Subject: Site Assessment and Pilot Test Workplan Addendum
Shore Acres Gas
403 East 12th Street, Oakland, Alameda County, California
RO #0002931
ECG # GHA.19009

Subject: Workplan Addendum to the *Site Assessment and Soil Vapor Extraction Pilot Test Workplan* dated February 9, 2011 for Fuel leak Case No. RO0002931, Shore Acres Gas, 403 12th Street, Oakland, California

Subject: Work Plan Denial for Fuel Leak Case No. RO0002931 and GeoTracker Global ID T0600174667, Shore Acres Gas, 403 E 12th St., Oakland, CA 94606

FIGURE 3

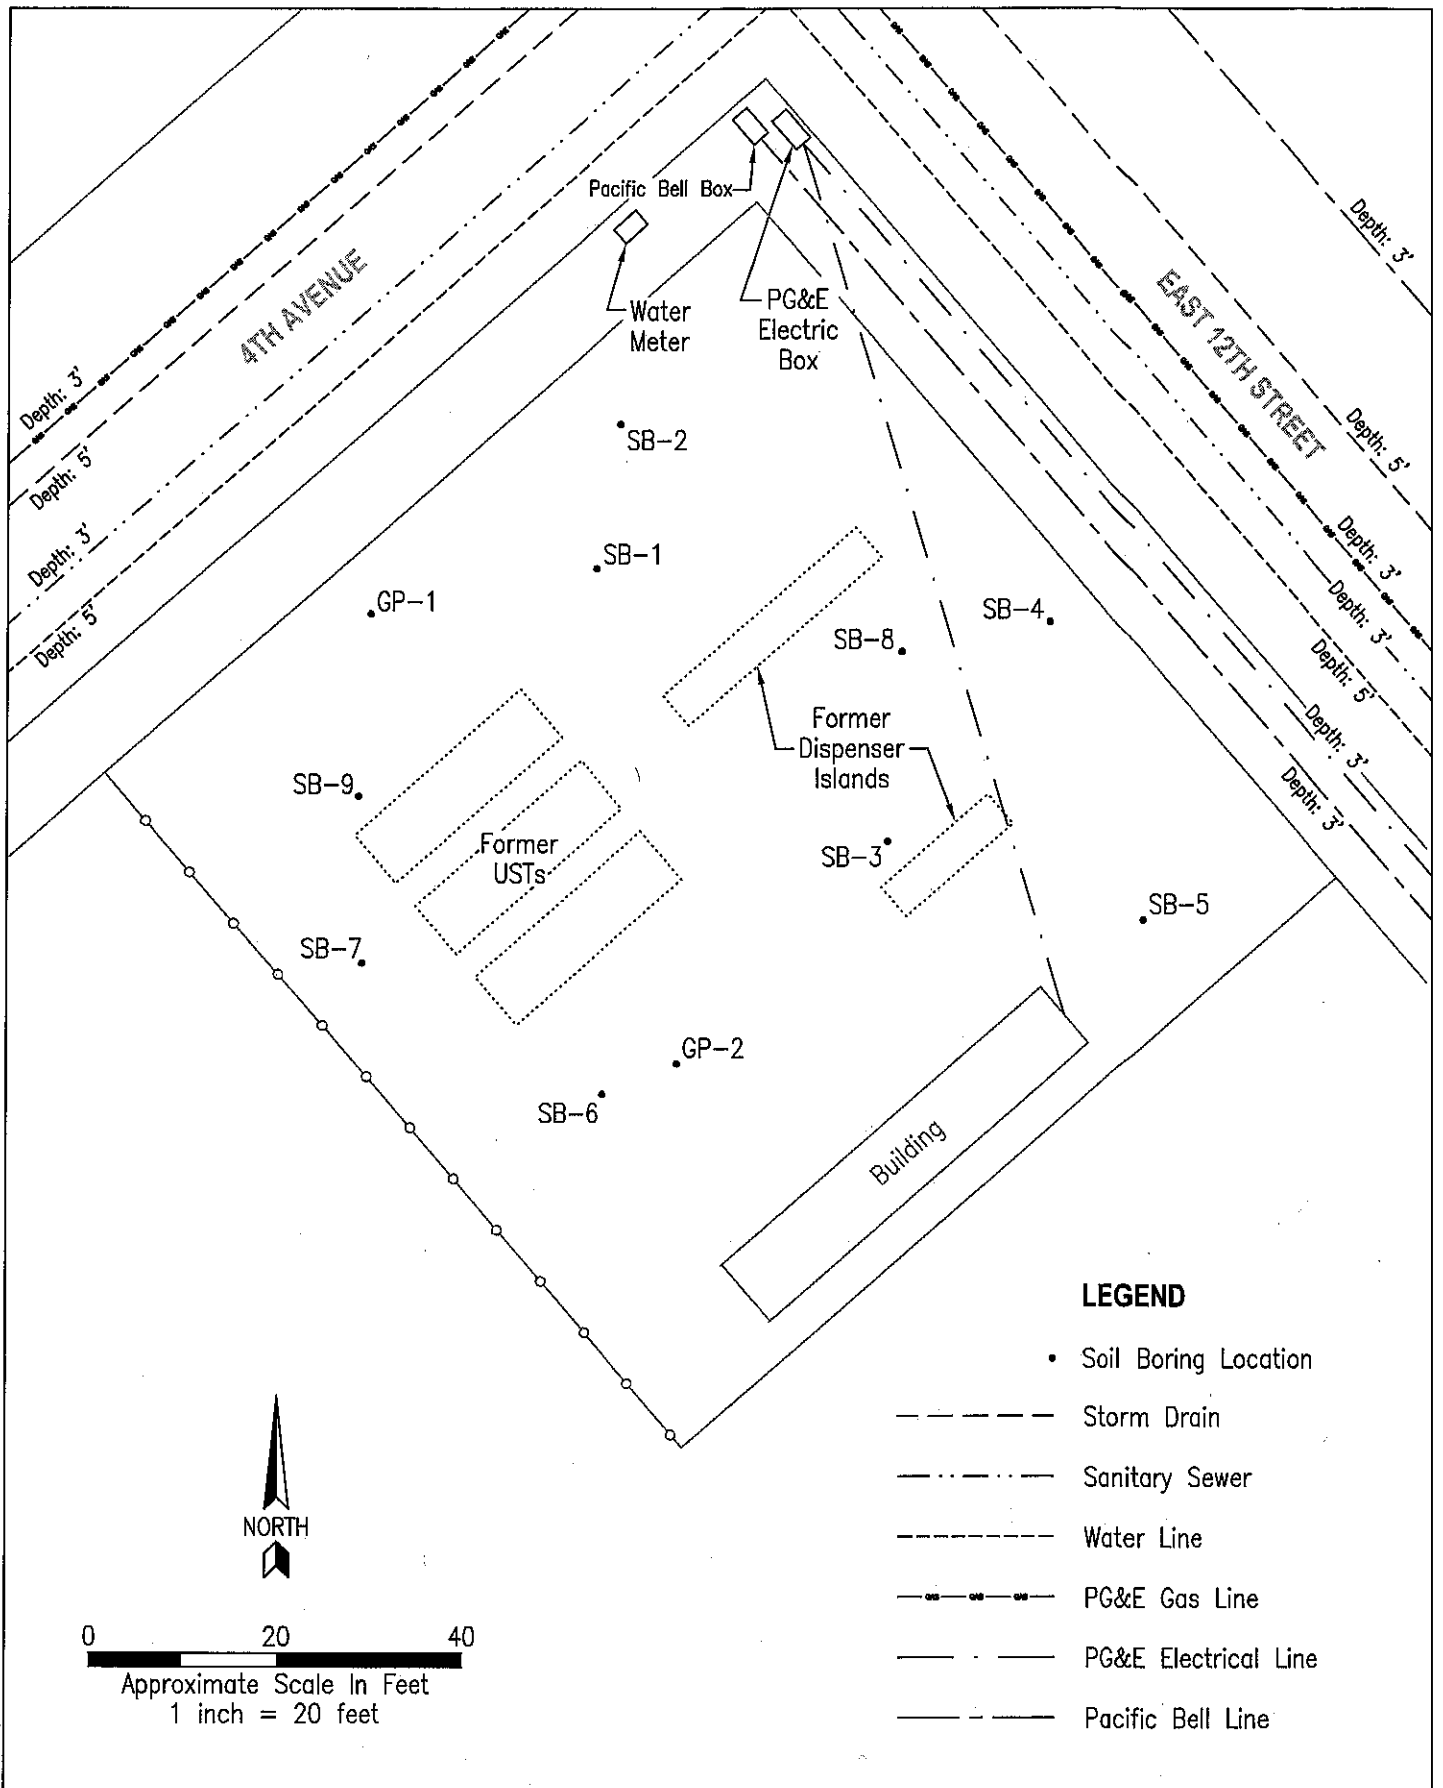
3. **Preferential Pathway Study** – Please include the depths of the utilities on your preferential pathway study map. Also, please place these conduits on an expanded site plan showing areas off site as well. The proposed offsite borings should be placed on this extended site plan which should be included in the work plan addendum requested below.

A revised preferential pathway with utility depths is included as Figure 3 and a downgradient preferential pathway and proposed soil boring location map is included as Figure 8. The underground utilities listed in the Workplan were extended to include the utility drawings listed in the *Phase I Environmental Site Assessment* for the Downtown Educational Complex prepared by Ninyo and Moore Geotechnical and Environmental Sciences Consultants located down gradient of the site.

All subsurface utilities found were very shallow, less than 5-feet bgs, and are unlikely groundwater conduits based on their depths. However, on the Figure 8, the downgradient preferential pathway map, a proposed soil boring (SB-10) has been included to address the potential for offsite migration along potential conduits along the south side of 4th Avenue. Soil samples and a grab groundwater sample will be analyzed for the constituents outlined in ECG's Workplan Report.

FIGURE 8
 Project Number:
 GHA.19009
 Date:
 April 14, 2011

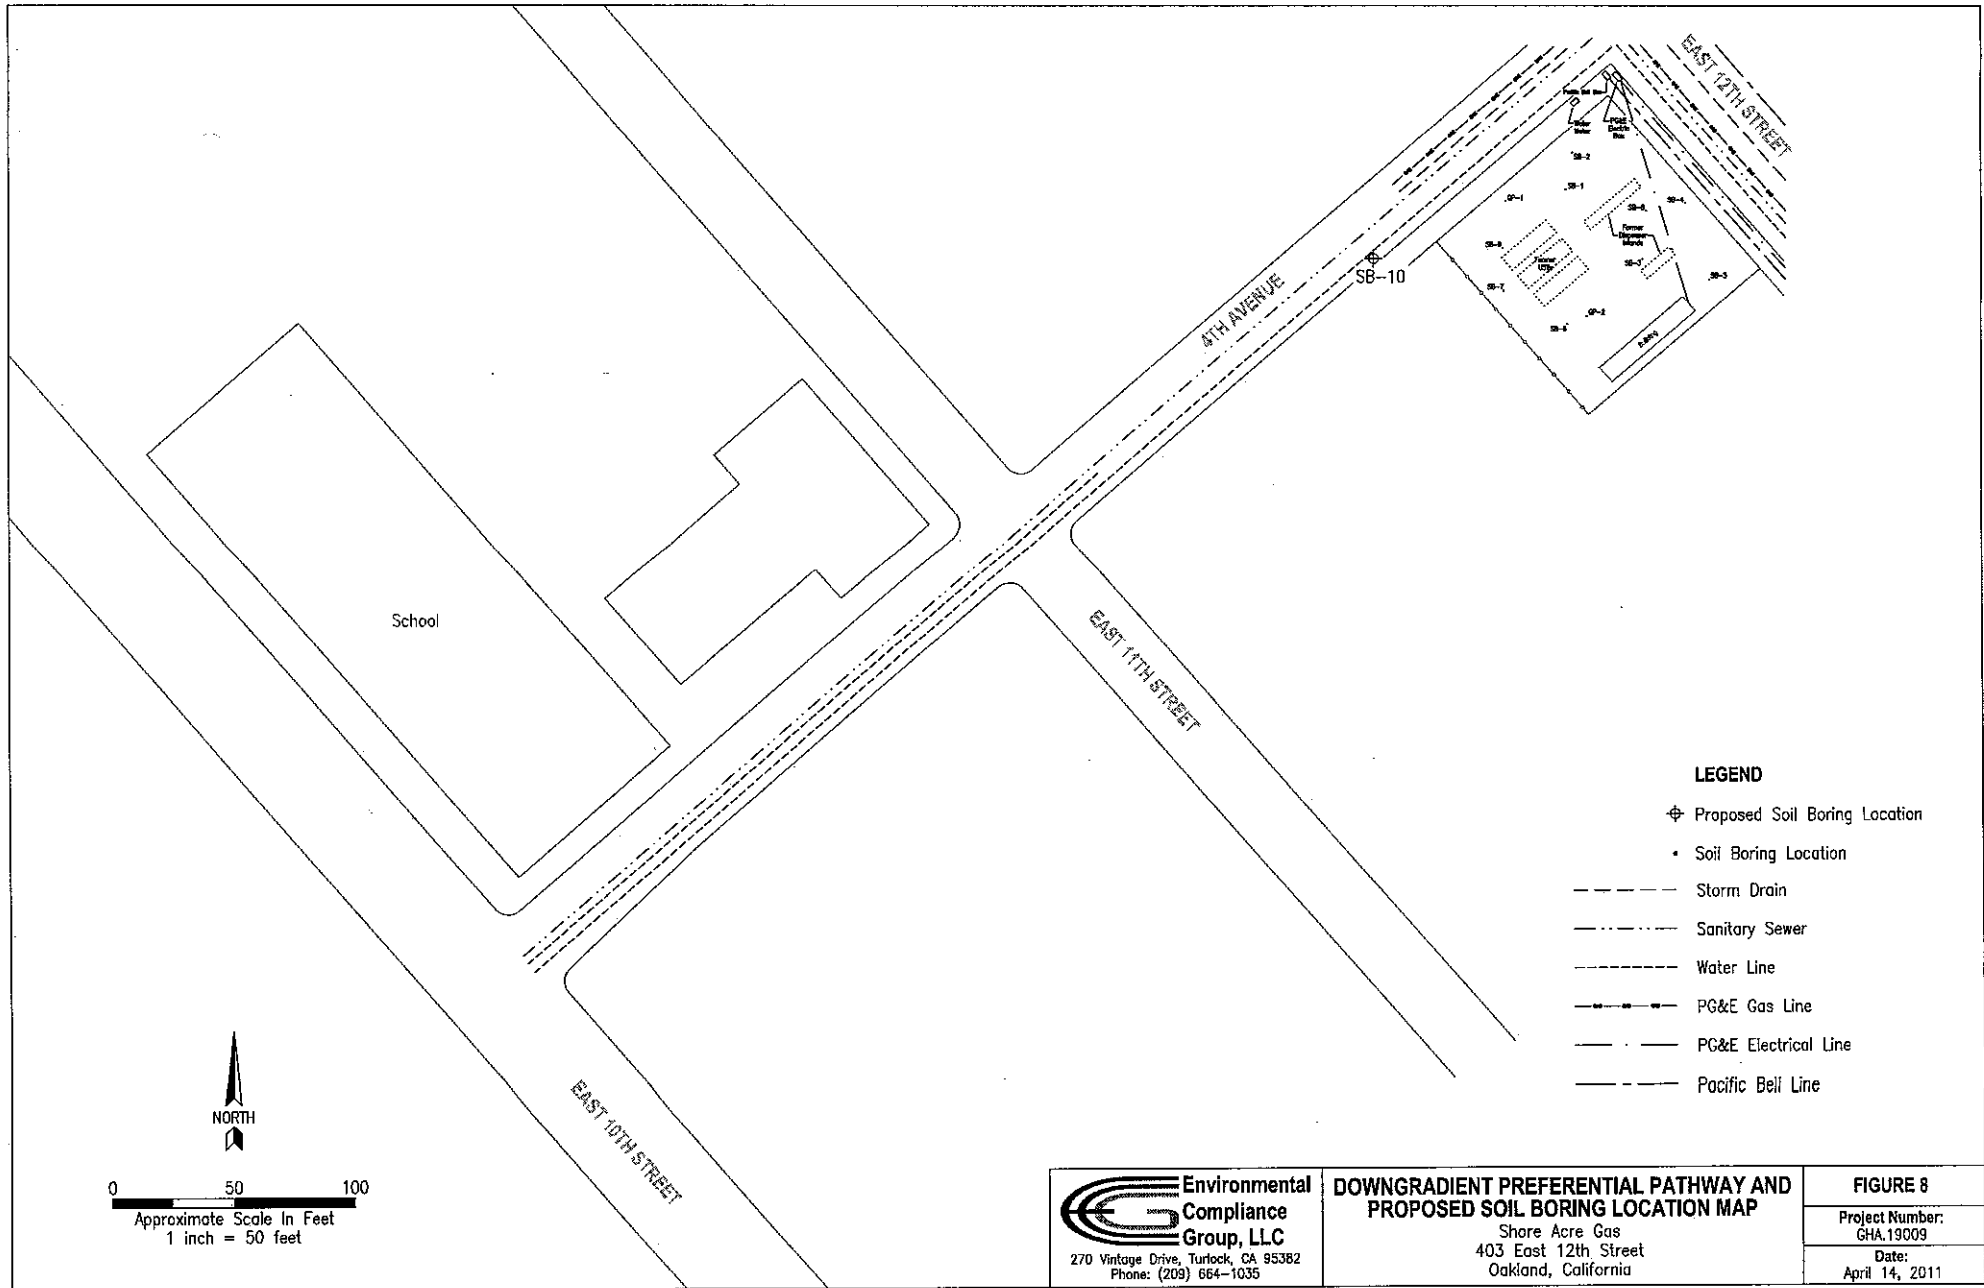
2. **Soil and Groundwater Characterization** – In our December 16, 2010 directive letter, ACEH requested an off-site investigation that evaluates contamination that may be moving onto the school property from your site. Further, MTBE contamination appearing to originate from your site has been detected at the school across the street. Please include in your proposed boring locations in the work plan addendum requested below.
